Access Compliance Report

Public Rights-of-Way

(Curb Ramps)

Intersection ID: 42780	Main Street: SILVERSWORD_DR	Cross Street: PURPLE_DAWN_DR	Location: SW
ADA ID: 736E588F1660	Ramp Type: BlendTrans1	Initial Pass/Fail: Fail	Overall Compliance: No
Severity Score: 8.75			
Codes/Mitigation Info/Possible Solution		Field Measurements/Component Compliance

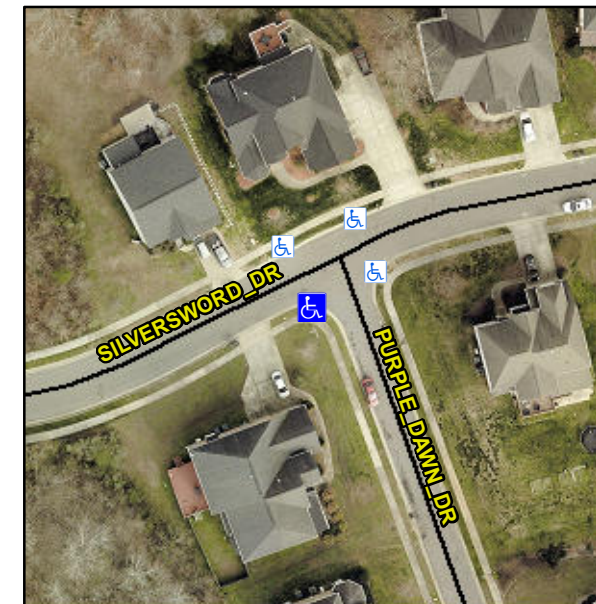
CURB GAP 1.5

Not Found, R304.5.1

Remove & Replace Curb Ramp With Two New Directional Ramps or Equivalent.
